FW: SRIC Comments on Class 3

May 20, 2013

RE: WIPP Class 3 Permit Modification Requests – Panel Closure System,
Repository Reconfiguration, and VOC Monitoring Program Revisions

FIGURE 1

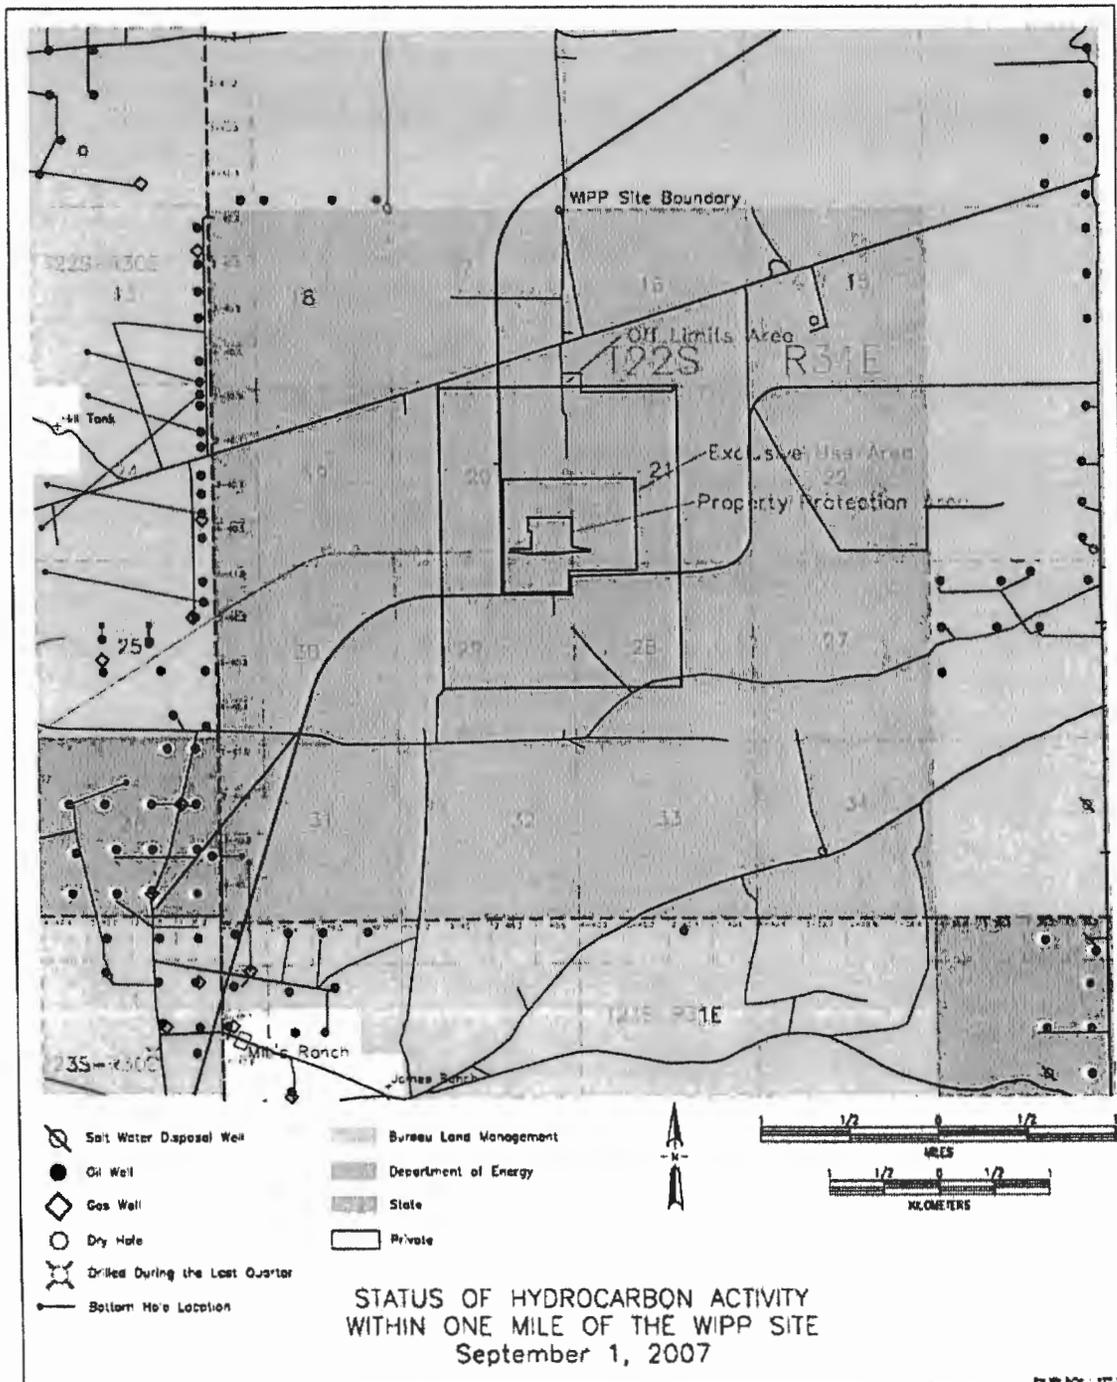
For example, results of borehole and probe holes surrounding Panels 4 and 5 are not provided. Further, moving panels closer to the southern boundary would result in waste emplacement closer to existing oil wells on the southern boundary of WIPP. Figure 1. That figure is as of September 1, 2007 and additional wells have been drilled in the vicinity of the WIPP site during the past 5+ years. The permittees should provide a current description and map of existing wells. Extending the panels further south will bring waste rooms closer to those wells. The permittees should provide an analysis of the impacts of drilling or other activities during the proposed almost 20 years of the continuing operation.

SRIC requests that in a response to a Notice of Deficiency or other method that the permittees provide the geophysical analyses and reports for the area surrounding Panels 4 and 5, including any features that could impact the performance of the two proposed panels. Further, the permittees should provide the location of oil and gas wells and other activities in proximity to

Panels 9A and 10A and analysis of how those activities could impact the performance of the panels.
